MANDATORY SERVICE BULLETIN

MSB 42-140/1

Type: DA 42, DA 42 M

Replacement of MLG axle.

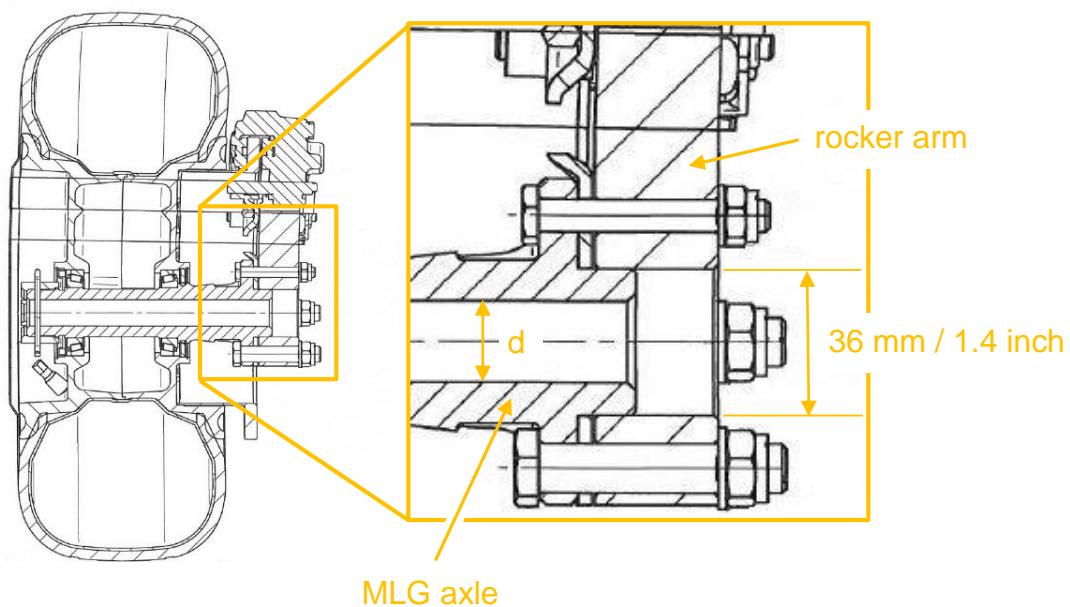
1. Measure the inner diameter **d** of the MLG axle of the left hand MLG and of the right hand MLG in accordance with the figure below.
2. If on both MLG axles the inner diameter **d** is 20 mm / 0.8 inch or 25 mm / 0.98 inch, no further measures are required. Make all necessary entries in the airplane logs.
3. If on one or on both MLG axles the inner diameter **d** is 14 mm / 0.55 inch, continue with step 4.

4. Replace all MLG axles, which have an inner diameter **d** of 14 mm / 0.55 inch with the latest MLG axle design in accordance with AMM, section 32-10.
5. Do a landing gear extension and retraction test in accordance with AMM, section 32-30.
6. Clean working areas, check for foreign objects.
7. Test all systems in working area for function.
8. Make all necessary entries in the airplane logs.
